# Norwich to Tilbury Powerline Project Targeted Consultation 25<sup>th</sup> February 2025 – 27<sup>th</sup> March 2025 Response from Chelmsford City Council

#### **1. OVERALL SUMMARY RESPONSE**

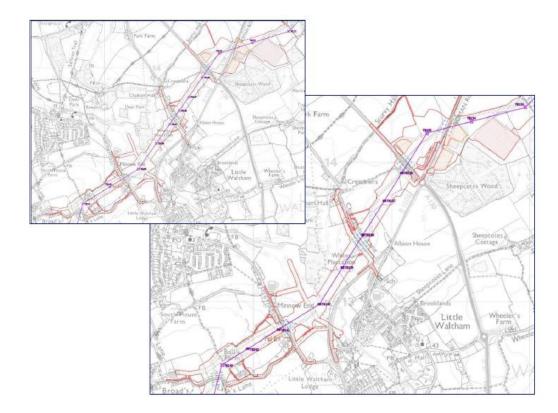
Although closer to a Local Wildlife Site and two additional tree / hedge lines being crossed, there would be no change to the type or significance of ecology and biodiversity effects as a result of the proposed change, when compared to the design and PEIR presented at statutory consultation."

- 5.36. Place Services state that the potential for works to be closer to the Lyonshall Wood Local Wildlife Site (LoWS) (ancient woodland) is notable, though it is reasonable to anticipate that mitigation (buffering) could/would be employed to avoid direct impacts to the Lyonshall Wood LoWS.

- 5.38. Without any ecological survey information, Place Services state that they are prohibited from reaching a fully informed conclusion on the significance of the proposed change with regard to potential ecological impacts.

Figure 5.13 Indicative alternative route - Great Waltham

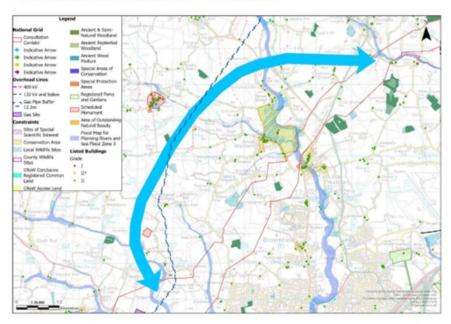
- II) Alternatively, different alignment should be chosen with further consideration being given to relocating the route to the north of Great Waltham and Little Waltham. Details of this route can be found at page 58, figure 5.13, Indicative alternative route of the Norwich to Tilbury Design Development Report June 2023 as illustrated below:

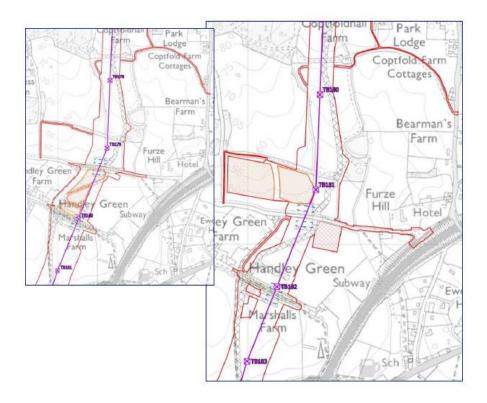
5.90. Place Services Ecology refer to the Environmental Implications of Change report which states:

"The proposed change would move the alignment further away from Langley's Deer Park Local Wildlife Site. In addition, greater vegetation clearance would be needed for the proposed low height towers. However, with appropriate mitigation, there would be no change to the type or significance of ecology and biodiversity effects as a result of the proposed change, when compared to the design and PEIR presented at statutory consultation."
